SB-GA8-2013-99

Service Bulletin

Inspection and modification of Strut Pick-up ribs – Rib no. 5 and Rib no. 6

Issue 3: Part 1 and 2 enhanced. Parts 3, 4 and 5 added.

Figure 5: Fuselage Skin Modification

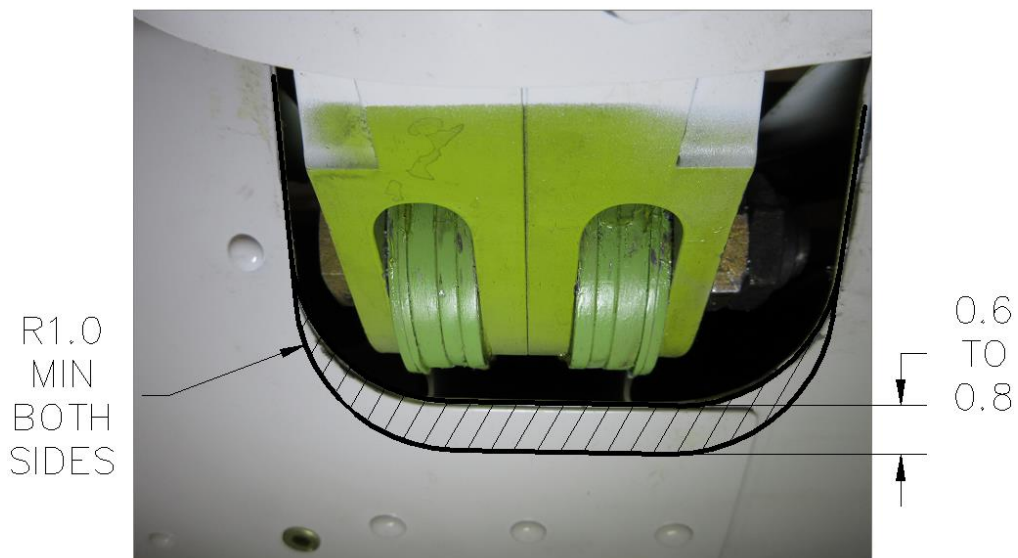
- 1) Enlarge the cut out in the Forward Cabin Belly Skin (P/N GA8-533021-113), Aft Cockpit Belly Skin (P/N GA8-533021-111) and Fuselage Strut Skin Doubler (P/N GA8-533022-095) to the dimensions shown in Figure 5. De-burr and finish all blended edges with a Scotch-Brite® pad or similar to achieve a surface finish of at least 125 microinch Ra (3.2 micron Ra).

Figure 6: Fuselage Rib Modification.
Tolerance on dimensions +/-0.01"

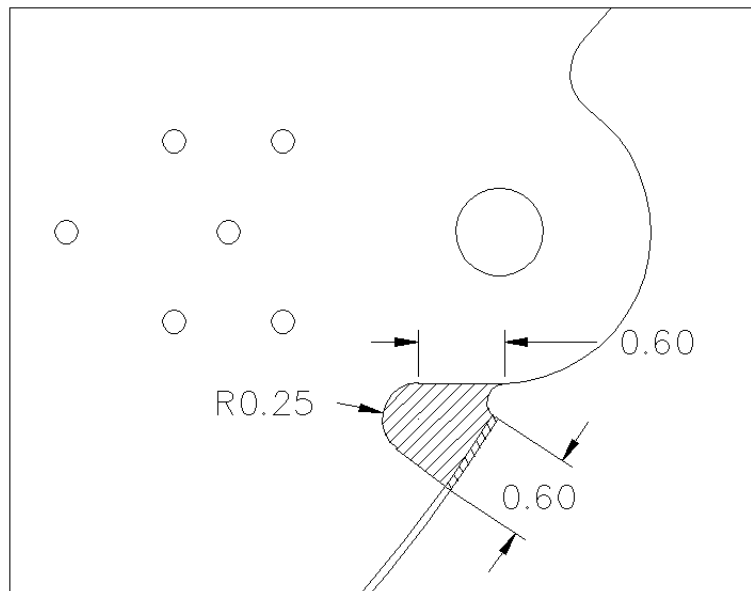
- 1) Remove material in the shaded area by blending to achieve the dimensions shown in Figure 6.

De-burr and finish all blended edges with a Scotch-Brite® pad or similar to achieve a surface finish of at least 125 microinch Ra (3.2 micron Ra).

Figure 10: Centre Floor Skin Access Holes

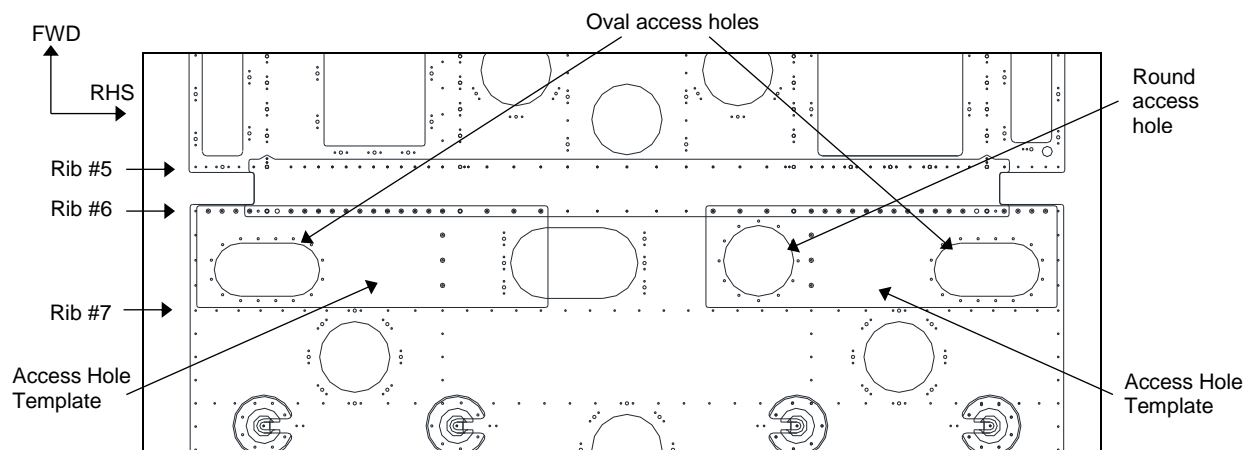
- 1) Position P/N GA8-533028-037 Access Hole Template Centre on the Floor Skin as shown in Figure 10.
- 2) Mark the locations of the oval-shaped access hole and adjacent fastener holes on LHS of the Centre Floor Skin using Access Hole Template. (See Figure 10).
- 3) Mark the locations of both the round and oval-shaped access hole and adjacent fastener holes on RHS of the Centre Floor Skin. (See Figure 10).

- 4) Remove template. Cut access holes and drill satellite holes using a #30 drill, to a diameter of 0.129".
- 5) De-burr and finish all blended edges with a Scotch-Brite® pad or similar to achieve a surface finish of at least 125 microinch Ra (3.2 micron Ra).

Figure 11: Centre Floor Cut-Out Region – LHS viewed from above

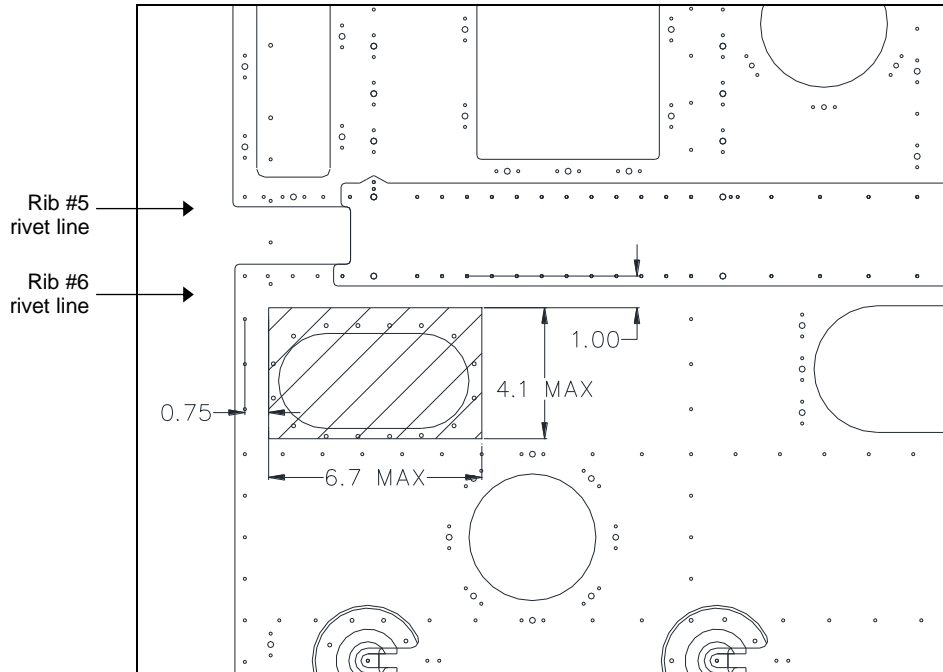
- 1) Cut the LHS and RHS floor skin in the shaded region shown in Figure 11. Make sure the edge of the cut-out remains at least 0.350" from any rivets.
- 2) De-burr and finish all blended edges with a Scotch-Brite® pad or similar to achieve a surface finish of at least 125 microinch Ra (3.2 micron Ra).
- 3) Apply a primer to the edges that conforms to MIL-PRF-23377F (or later approved revision) or FED-SPEC-TT-P-1757B (or later approved revision).

Figure 25: Typical installation of Temporary Doublers (Rib #5 and GA8-532024-021 shown)

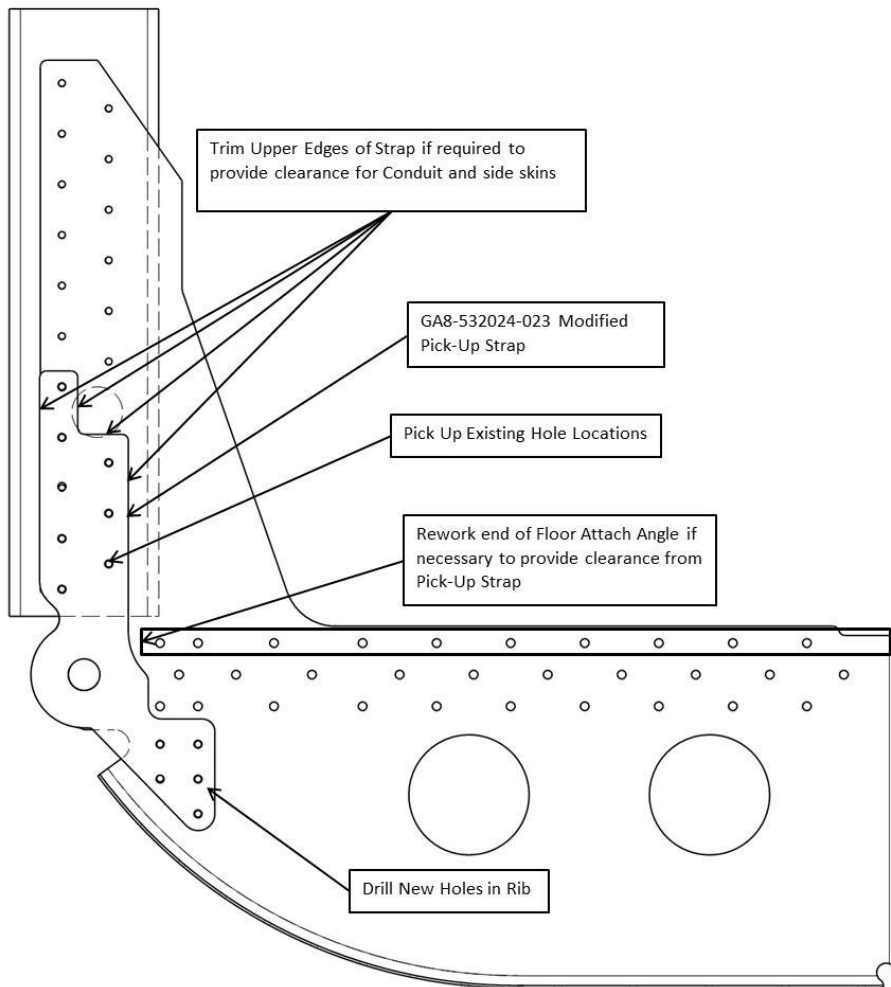
- 4) Position the Modified Fwd and Aft Strut Pick-Up Straps on Rib 5 and 6 (See Figure 25).
- 5) Temporarily install the wing strut attachment bolt to ensure the 0.625" holes of the Modified Fwd and Aft Strut Pick-Up straps are concentric with the Rib and Carry-Through Straps.

- 6) Verify adequate structural clearance is obtained from adjacent structure including the Floor Attach Angle (GA8-532021-033), cabin sidewall skins and the Cockpit Door Aft Gusset (See Figure 25).
If adequate clearance exists proceed to Step (12) otherwise continue with Steps (7) through (11) as necessary.

- 7) If required, trim the outboard end of Floor Attach Angle (GA8-532021-033) to ensure clearance from Modified Fwd and Aft Strut Pick-Up Straps (See Figure 25).

- 8) If required, trim the upper edges of the Modified Fwd and Aft Strut Pick-Up Straps to ensure adequate structural clearance from the cabin wall side skin (See Figure 25).

- 9) If required, trim the upper edges of the Modified Fwd Strut Pick-Up Strap to provide clearance for the aileron cable conduit penetration (See Figure 25).

- 13) Drill fastener holes using a #20 drill to a diameter of 0.161" through the web of Rib 5 and 6 using the pilot hole locations in the lower leg of the Modified Fwd and Aft Strut Pick-Up Straps (See Figure 25). De-burr holes.

- 14) Install CR3213-5-03 rivets (confirm grip length prior to installation) at the existing hole locations in the Rib and Main Spar Side Pillar Assembly (See Figure 25).

- 15) Install CR3213-5-03 rivets (confirm grip length prior to installation) at the new hole locations in the Rib and Modified Fwd and Aft Strut Pick-Up Straps (Qty 5 per Rib, See Figure 25).

Figure 26: Floor Skin Patch – Extended Seat Rails (dimensions in inches)

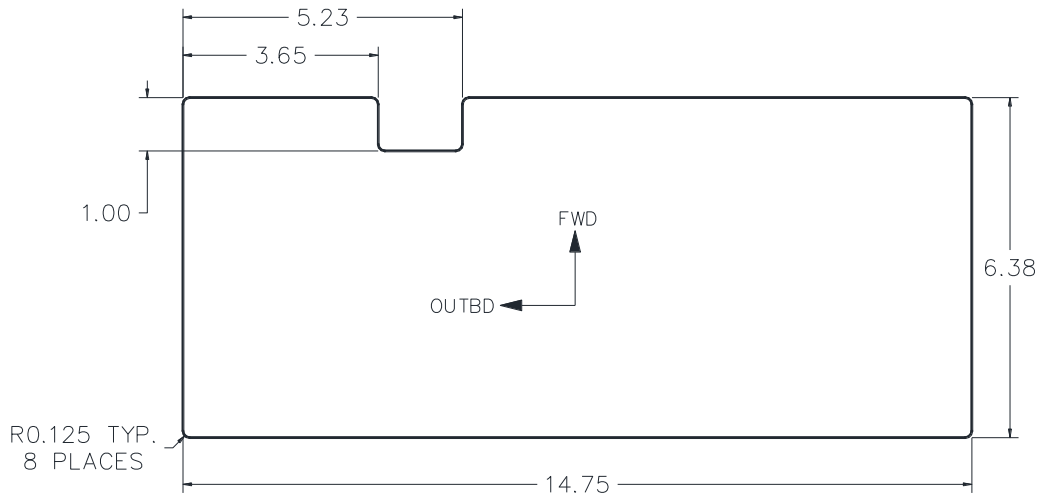
- 1) Manufacture a Floor Skin Patch for each side using 2024-T3 clad aluminium per SAE-AMS-QQ-A-250/5 with a thickness of 0.040" to the dimensions shown in Figure 26 for aircraft with extended seat rails or in Figure 27 for aircraft with regular seat rails.
- 2) De-burr the part(s).

Figure 34: Trimming of Floor Attach Angle.

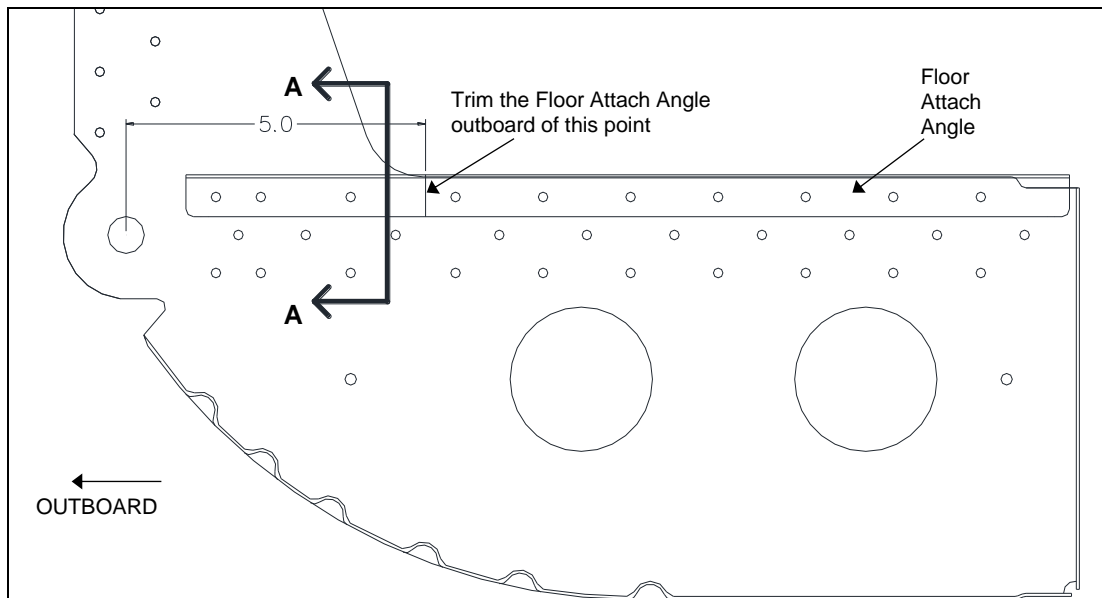
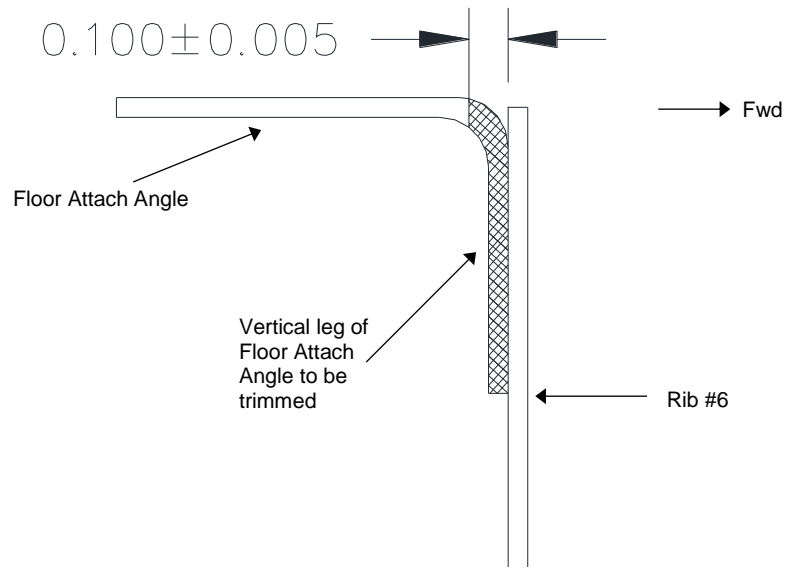
- 1) Trim away $0.100'' \pm 0.005''$ on the outboard end of the vertical leg of the Floor Attach Angle (GA8-532021- 33/34) as shown in hatched area of Figure 35 for a length of $5.0'' \pm 0.100''$ inboard of the rib lug end bore (See Figures 34 and 35).
- 2) De-burr and finish all blended edges with a Scotch-Brite® pad or similar to achieve a surface finish of at least 125 microinch Ra (3.2 micron Ra).
- 3) Apply a primer to the edges that conforms to MIL-PRF-23377F (or later approved revision) or FED-SPEC-TT-P-1757B (or later approved revision).

Figure 36: Floor skin to be trimmed. LHS shown, RHS is opposite.

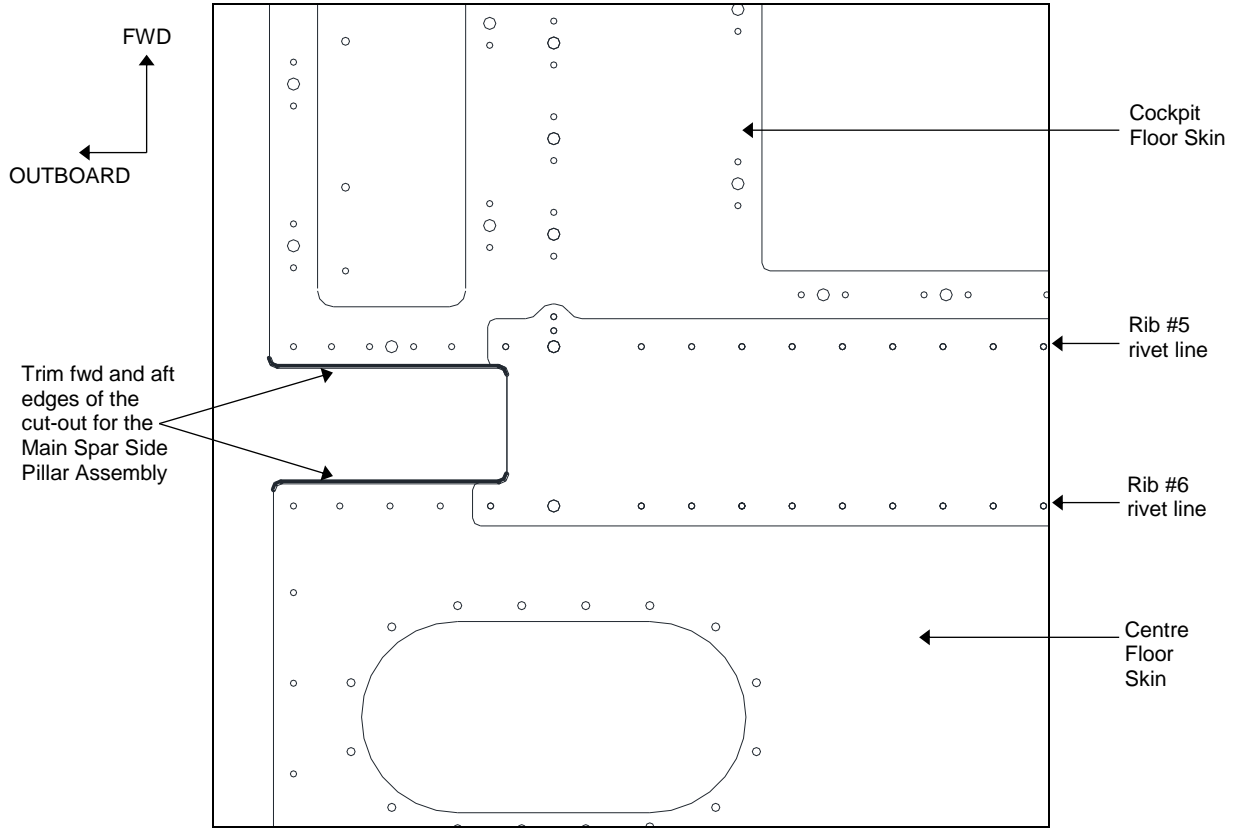
- 1) Trim aft edge of Cockpit Floor Skin by 0.100" +/- 0.005" as shown in Figure 36.
- 2) Trim forward edge of Centre Floor Skin by 0.100" +/- 0.005" as shown in Figure 36.
- 3) De-burr and finish all blended edges with a Scotch-Brite® pad or similar to achieve a surface finish of at least 125 microinch Ra (3.2 micron Ra).
- 4) Apply a primer to the edges that conforms to MIL-PRF-23377F (or later approved revision) or FED-SPEC-TT-P-1757B (or later approved revision).

Figure 37: Typical installation of Permanent Doublers.

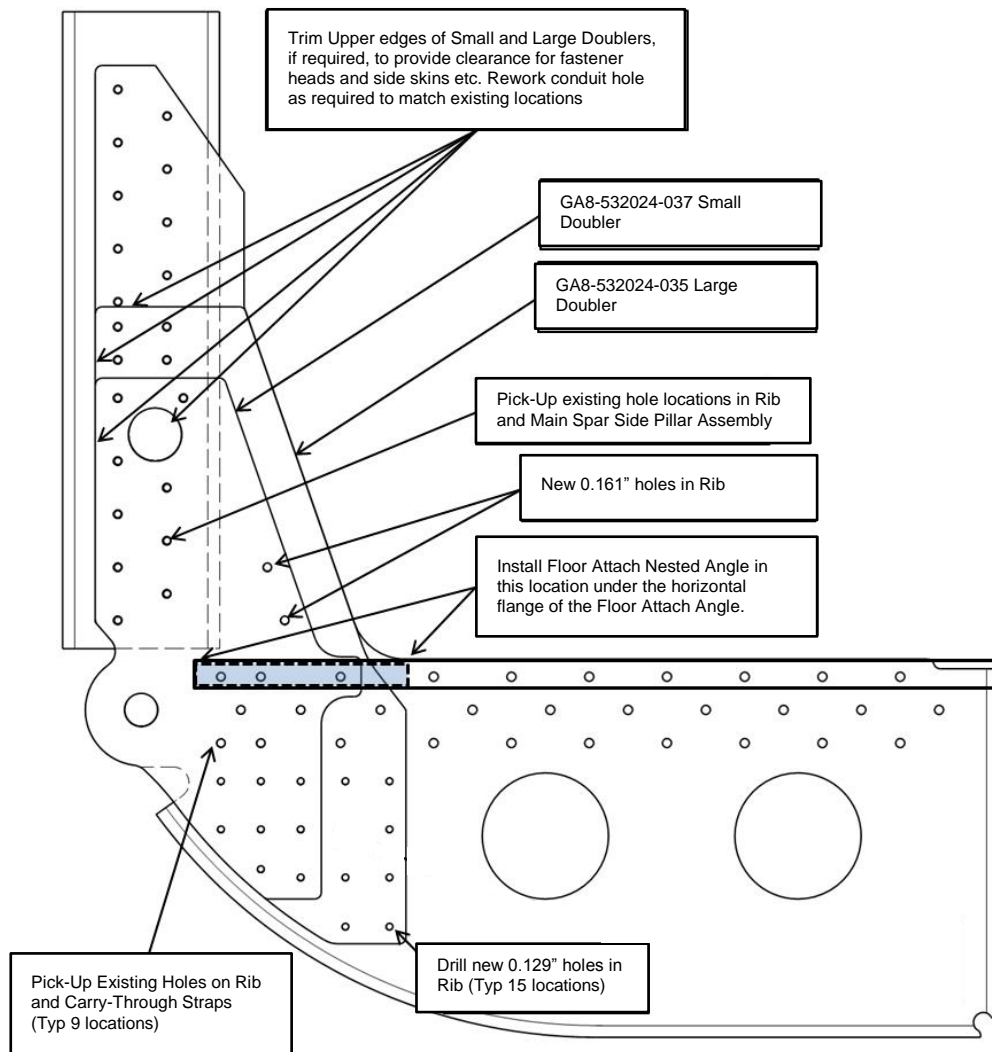
- 1) Position the Large and Small doublers on Rib #5 and #6 (See Figure 37) and temporarily install the wing strut attachment bolt to ensure the lug bore of the Doublers are concentric with the Rib and Carry-Through Straps. Pin the doublers in position.
- 2) Position the Floor Attach Nested Angle (GA8-532024-029) under the horizontal flange of the floor attach angle at each Rib location (See Figure 37).
- 3) Match drill the 5/32" holes, at 0.161" diameter, (See Figure 37) from the Rib to Carry-Through Strap attachment locations to the vertical flange of the Floor Attach Nested Angle.
- 4) Match drill the holes from the Floor Attach Angle horizontal flange to the horizontal flange of the Floor Attach nested Angle.
- 5) Remove the Floor Attach Nested Angle and de-burr holes.

- 1) Position the Small and Large Doublers on Rib #5 and #6 (See Figure 37) and temporarily attach the Wing Strut attachment bolt to ensure the lug bores of the Doublers are concentric with the Rib and Carry-Through Straps.
- 2) Verify adequate clearance is provided from adjacent structure including: the Floor Attach Angle, Cabin Side-Wall Skins (See Figure 37). Also ensure that the Large Doubler inboard vertical edge does not project beyond the Rib #5 and #6 inboard edge profile. If adequate clearance exists with Large and Small doublers in position then proceed to Step (10) otherwise continue with Steps (4) through (9) as necessary.
- 3) Trim, if required, the outboard end of Floor Attach Angle to ensure clearance from the Large and Small Doublers (See Figure 37).

- 4) Trim, if required, the upper edges of the Large and Small Doublers to ensure adequate structural clearance from the Cabin Side-Wall Skins and to avoid fouling on any rivet heads (See Figure 37).
- 5) Trim, if required, the penetration holes in the Large and Small Doublers to provide clearance for the aileron cable conduit penetration (See Figure 37).
- 6) Trim, if required, the inboard upper edge of the Large Doubler to ensure it is flush with the Rib #5 and #6 inboard edge profile.
- 7) Apply a primer to the edges that conforms to MIL-PRF-23377F (or later approved revision) or FED-SPEC-TT-P-1757B (or later approved revision).
- 8) Re-attach the Large and Small Doublers using the wing strut attachment bolt to locate bores concentrically. Clamp the doublers in position.

- 11) Install three MS20470AD5 rivets through the Floor Attach Nested Angle, Rib #5 and #6, Carry-Through Straps and the Large and Small Doublers (rivet grip length to be verified on installation) (See Figure 37).

- 12) Install quantity of four MS20470AD5 rivets through the Large and Small Doublers, Rib #5 and #6 and the Carry-Through Straps (rivet grip length to be verified on installation) (See Figure 37).

- 13) Install quantity of two MS20470AD5 rivets through the Large Doubler, Rib #5 and #6 and the Carry-Through Straps (rivet grip length to be verified on installation) (See Figure 37).

- 14) Install quantity of fifteen MS20470AD4 rivets through the lower web of Rib 5 and 6 and the Large and Small Doublers (rivet grip length to be verified on installation) (See Figure 37).

Figure 38: Cockpit Door Aft Gusset modification.

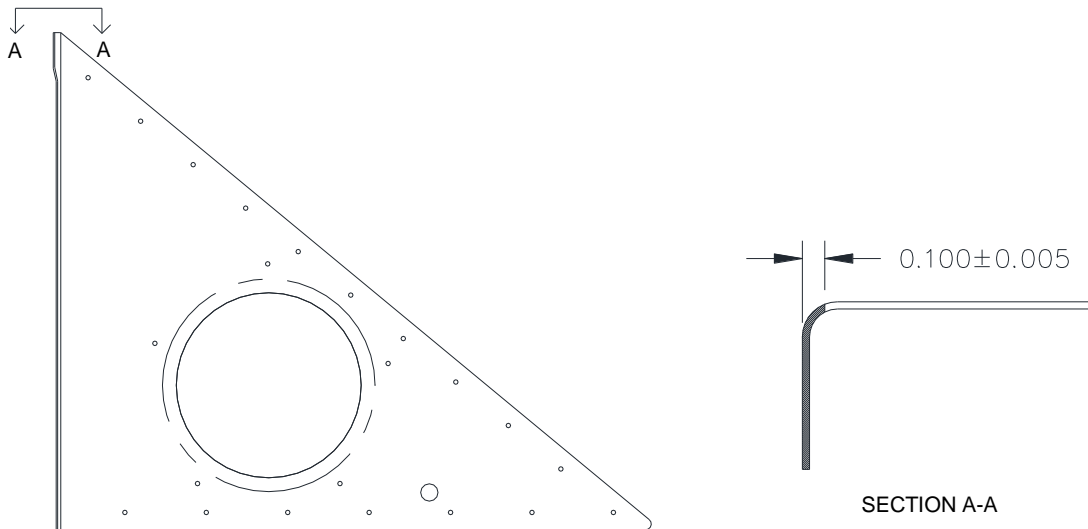
- 1) Trim the aft end of the Cockpit Door Aft Gusset(s) by 0.100" +/- 0.005" in the hatched area of Section A-A of Figure 38.
- 2) Apply a primer to the edges that conforms to MIL-PRF-23377F (or later approved revision) or FED-SPEC-TT-P-1757B (or later approved revision).

Figure 39: Cockpit Door Aft Gusset Angle attachment (LH shown, RH similar)

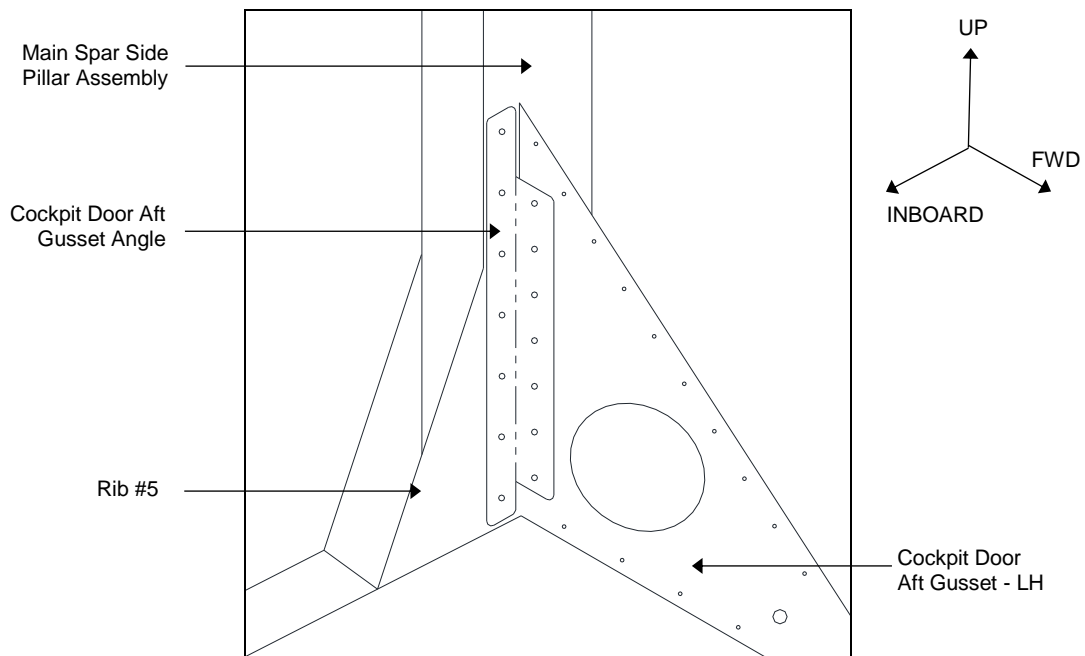
- 4) Locate the Aft Door Gusset Angle (GA8-532024-027) against the Cockpit Door Aft Gusset and the Main Spar Side Pillar Assembly, using packers as required.
- 5) Match drill holes from the Main Spar Side Pillar Assembly into the Aft Door Gusset Angle and packer(s), using a #20 drill to a diameter of 0.161" ensuring 0.35", or greater, edge distance is maintained for all holes. (See Figure 39).
- 6) Trim packers as required to match Aft Door Gusset Angle profile, as required.
- 7) Back-drill holes from the Aft Door Gusset Angle into the Cockpit Door Aft Gusset using a #20 drill to a diameter of 0.161" ensuring 0.35", or greater, edge distance is maintained for all holes. (See Figure 39).
- 8) Install CR3213-5 fasteners to attach the Aft Door Gusset Angle to the Cockpit Door Aft Gusset (Assess rivet length on installation).
